## ST. TAMMANY PARISH

**Addendum No.:**4

**Bid#:** 24-62-2

**Project Name:** Cross Gates Wastewater Treatment Plant Improvements

SHEET NO.  
2S-1

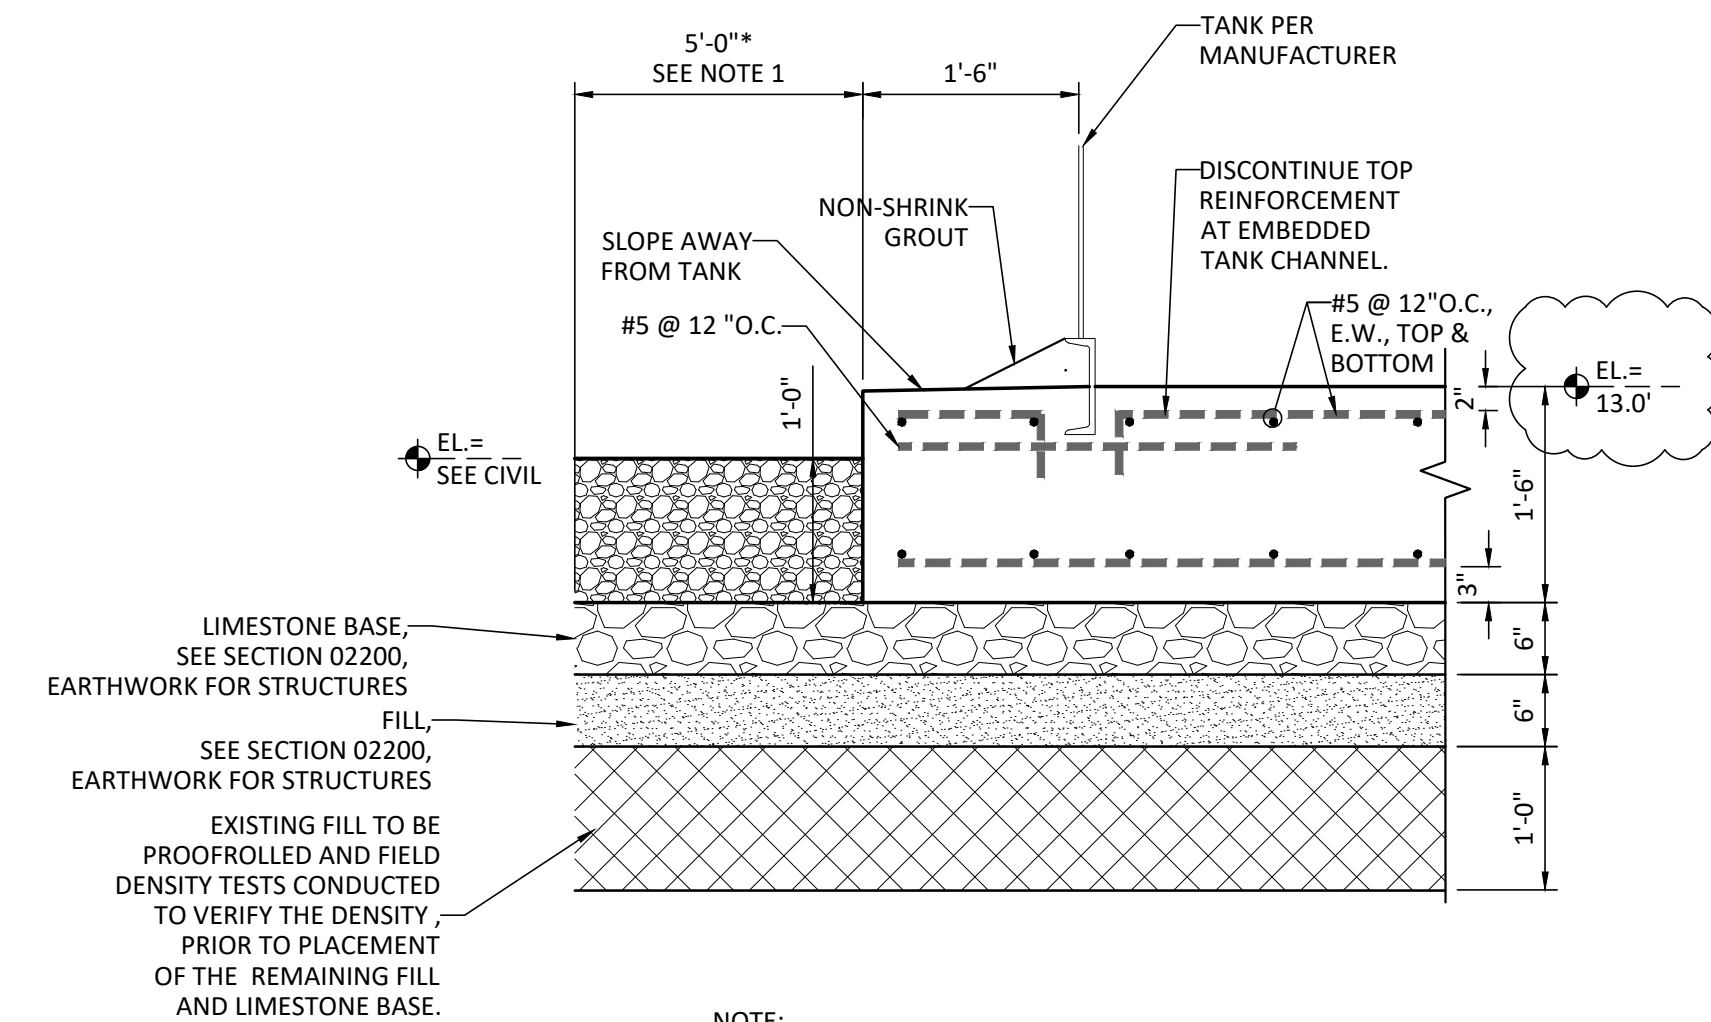
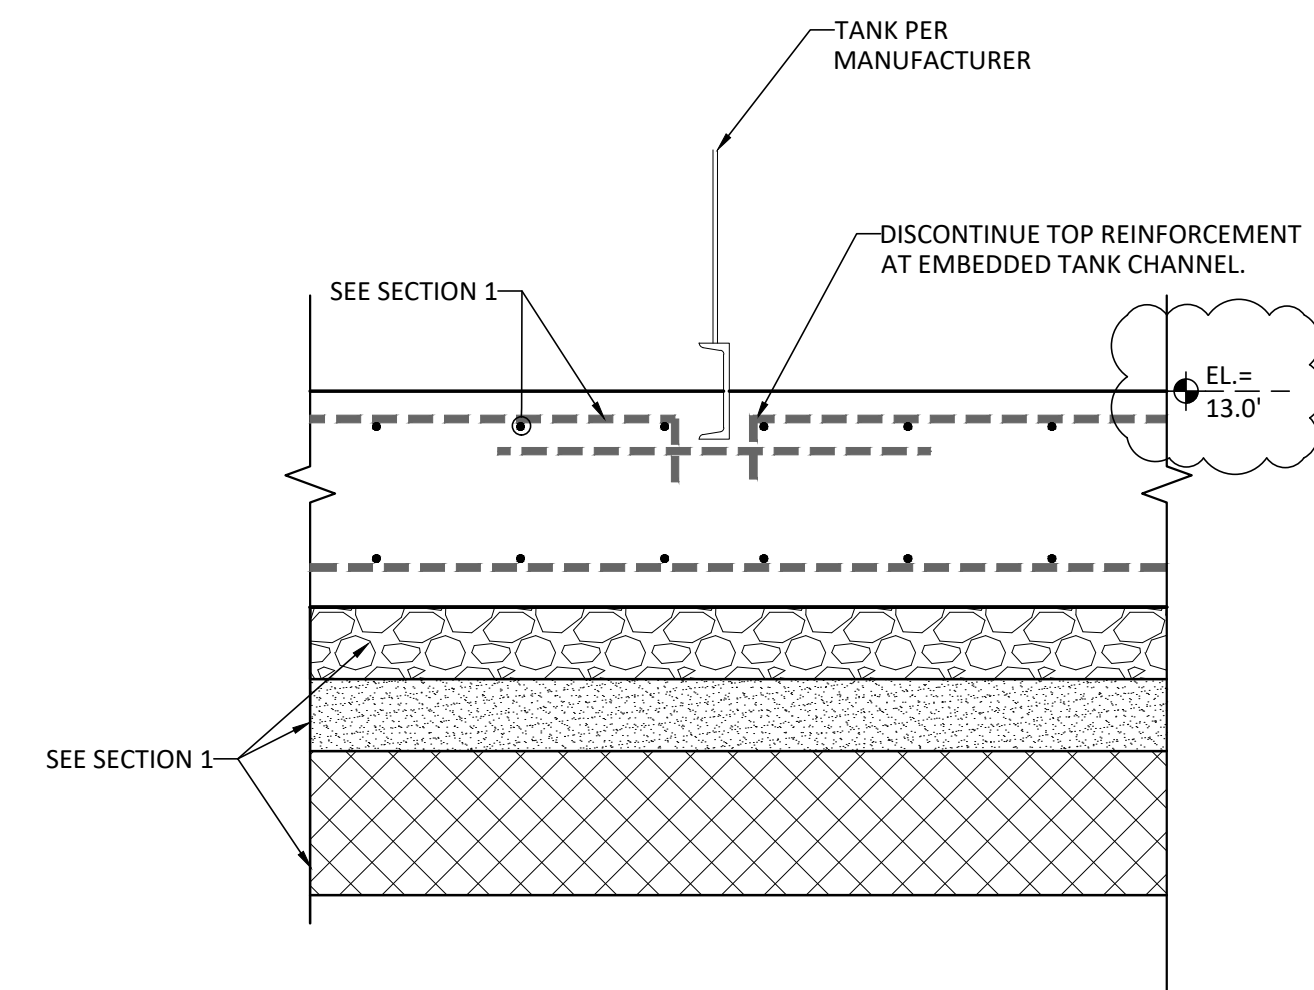
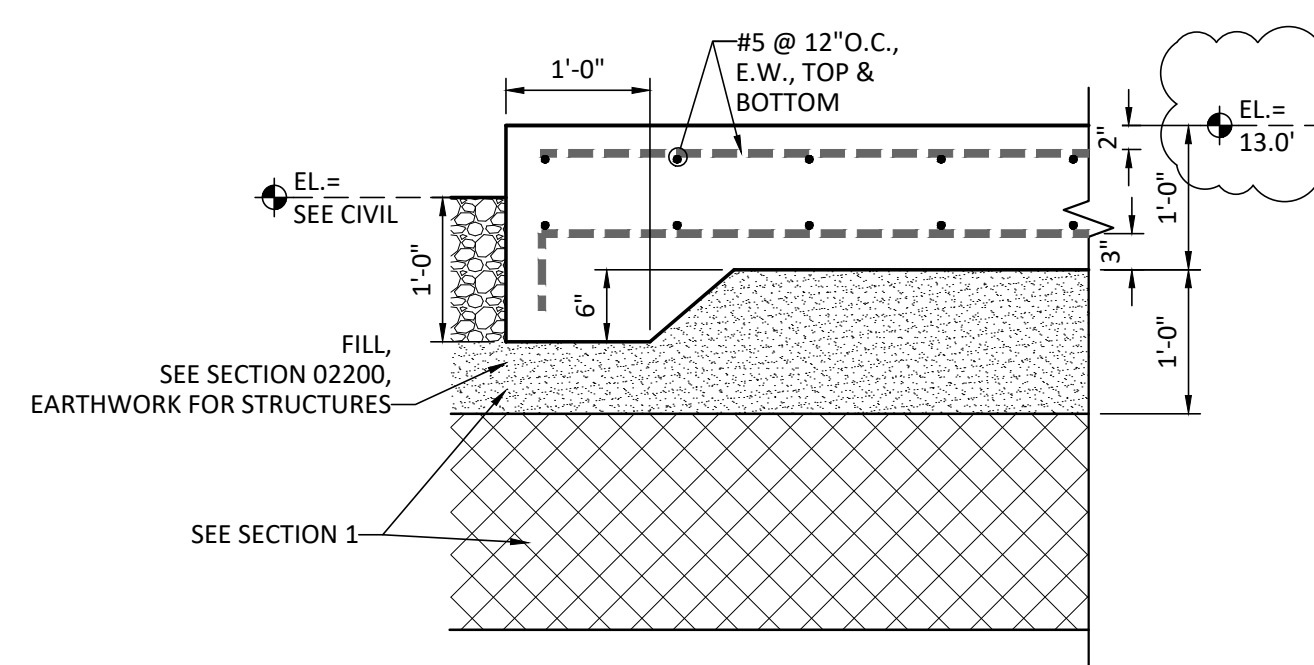
QUESTION 8: Sheet 2S-1 show FFE for tank foundation at 25.5'. Civil drawings have finished elevations much less than approx..13'. Is the 25.5 an error?

QUESTION 9: Sheet 2S-1 General note 1. what does that mean?

ANSWER 8: The correct elevation of the tank slab is 13.0'. Sheet 2S-1 has been revised.

ANSWER 9: Since the tank is divided into three different sections by bulkheads, it must be filled in stages to prevent over/uneven stressing to any of the walls, bulkheads, or the foundation.

SHEET NO.  
3S-1

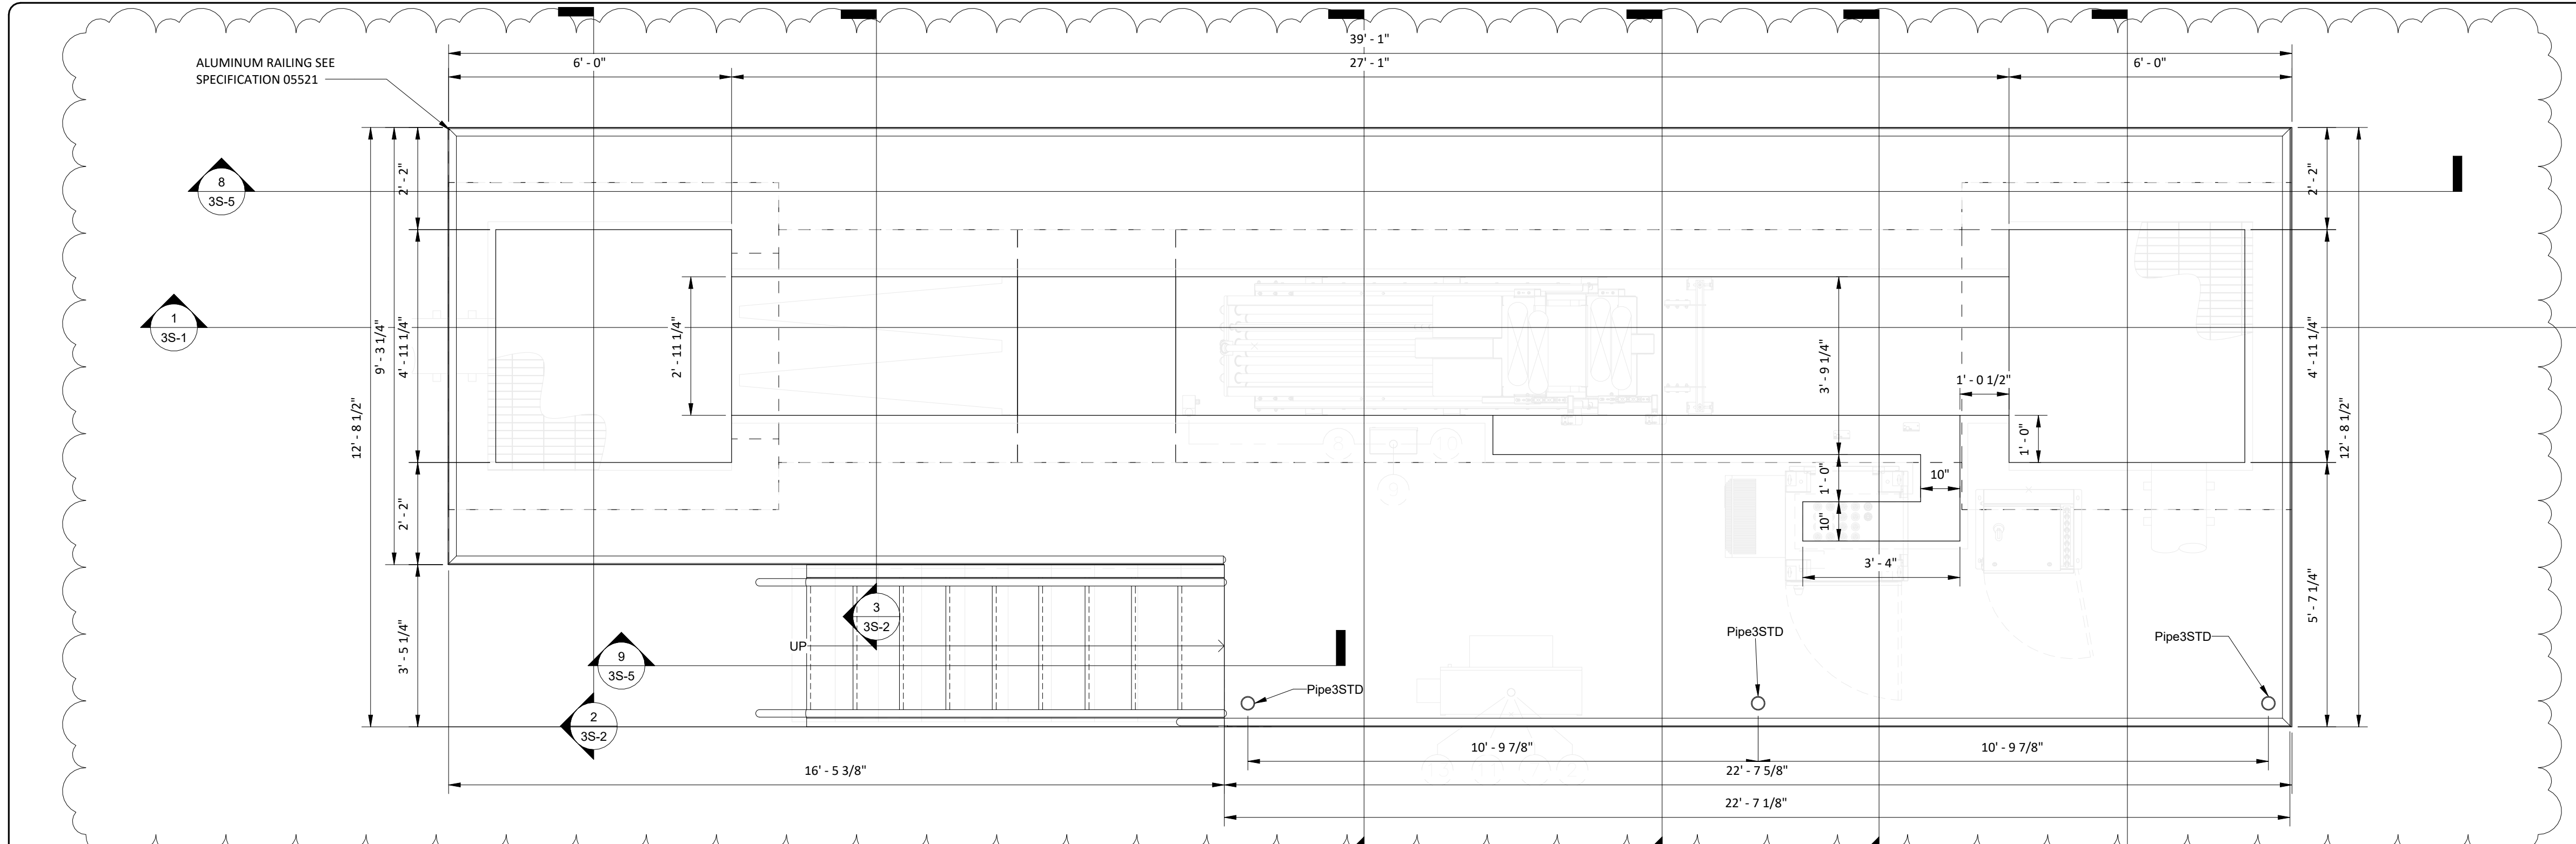
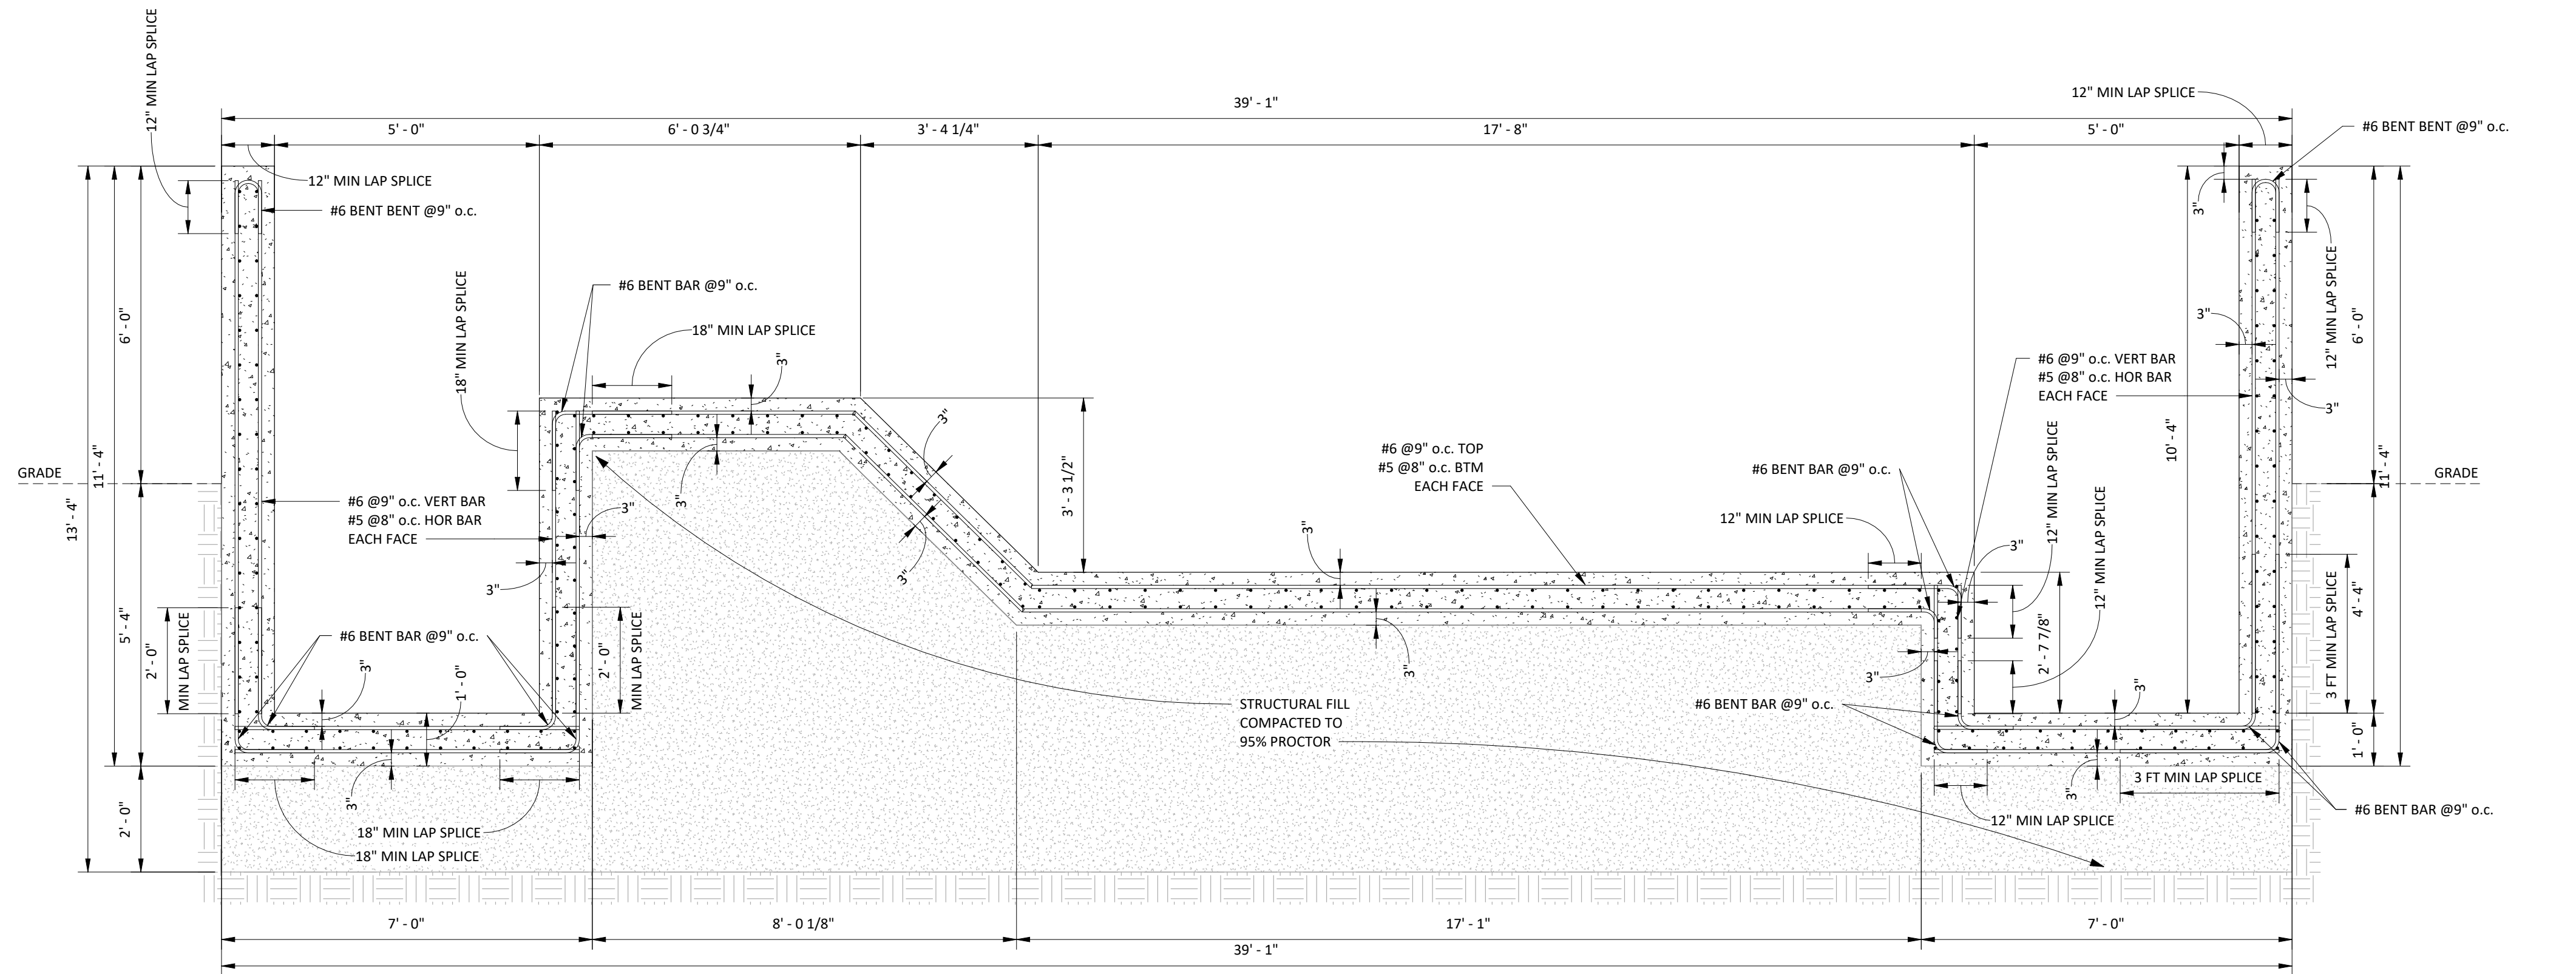
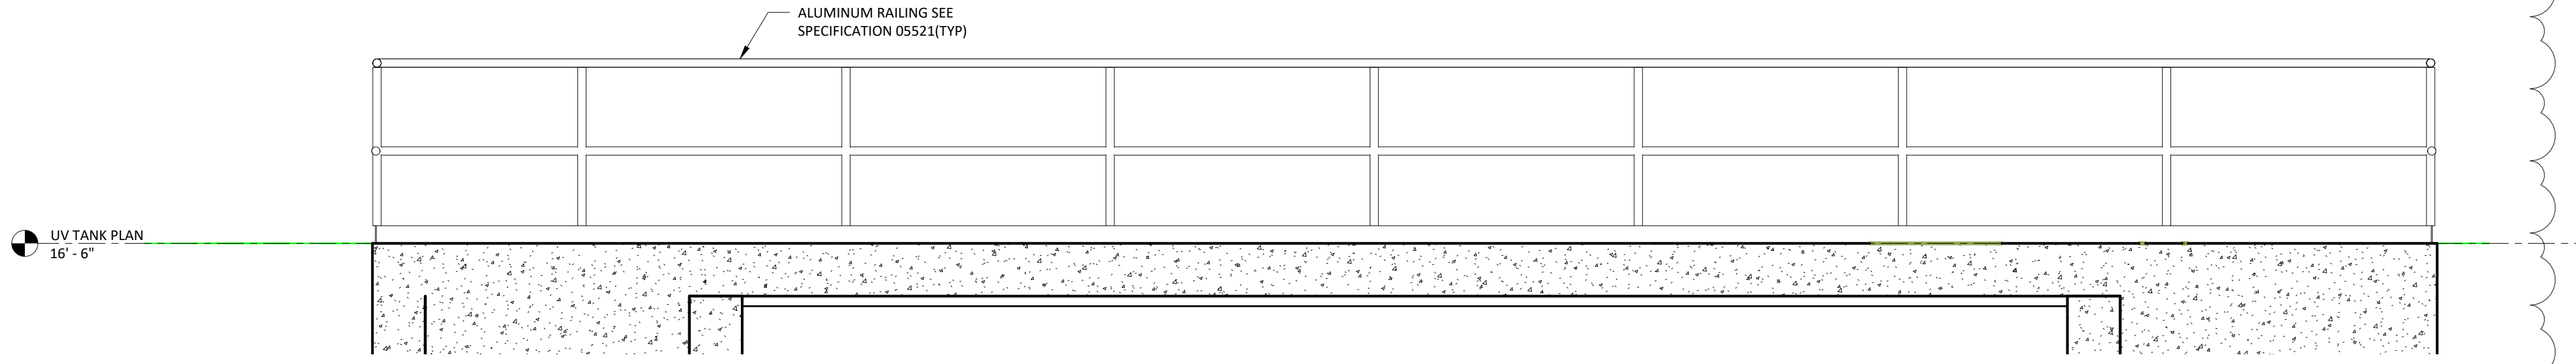
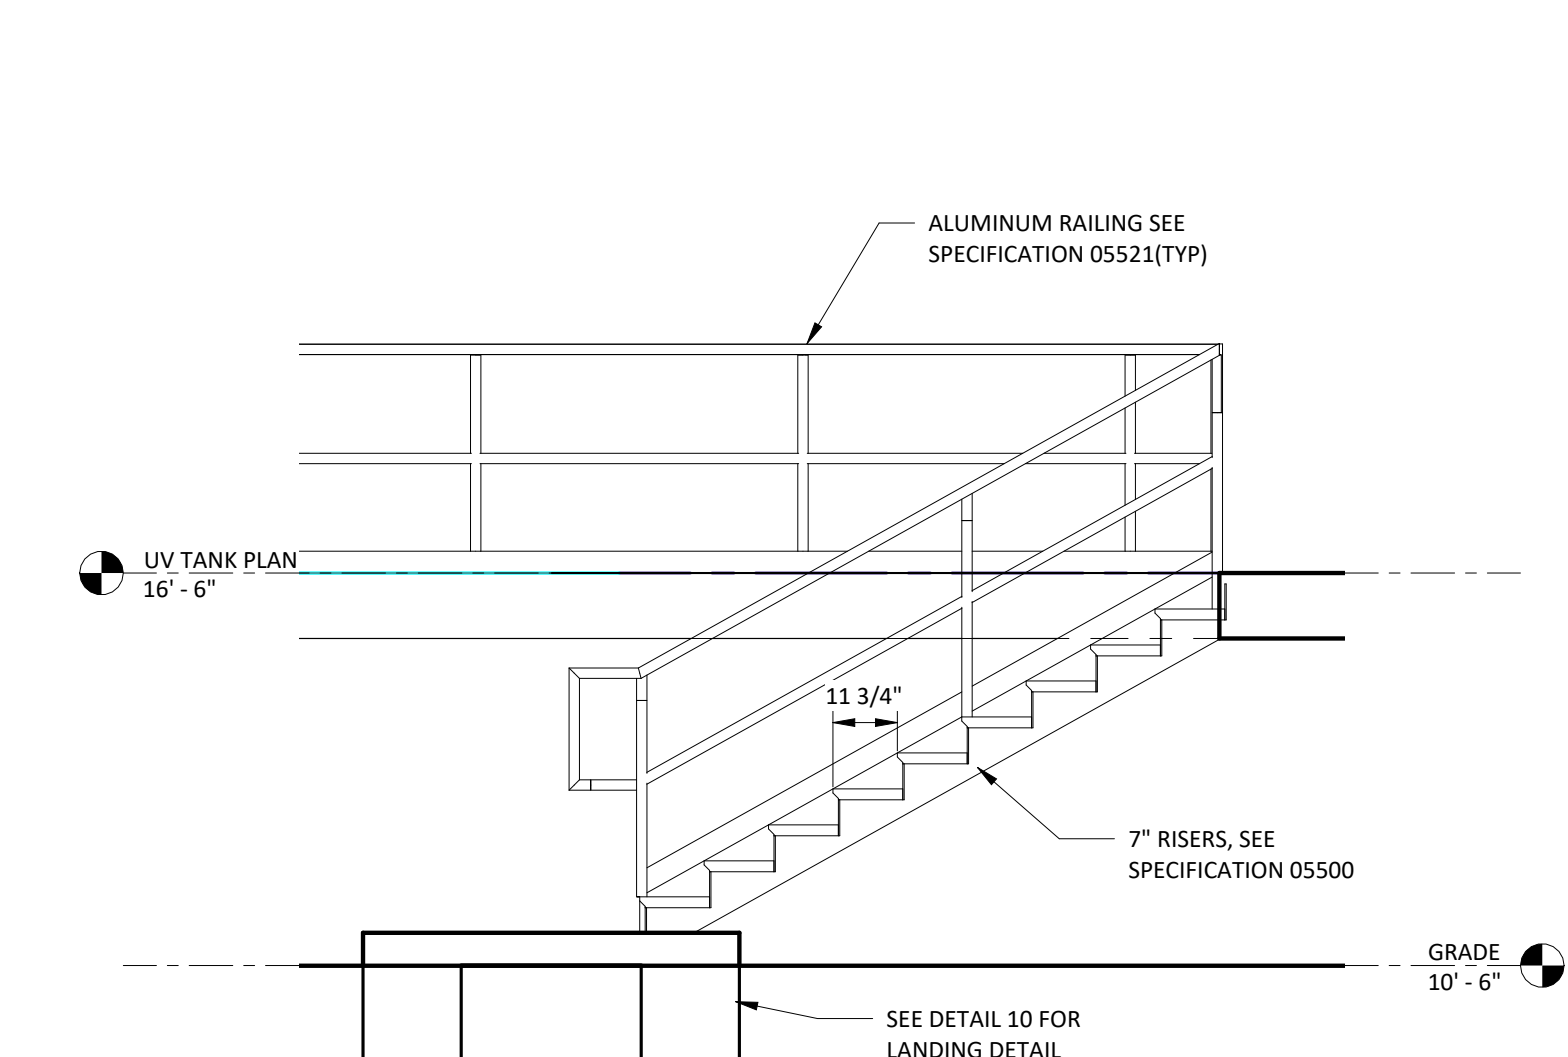
QUESTION 1: Will UV basin require hand rails?

ANSWER 1: Yes, hand rails are required. Drawing Sheet 3S-1 has been revised to indicate the requirement. Details have been added to Sheet 3S-5.
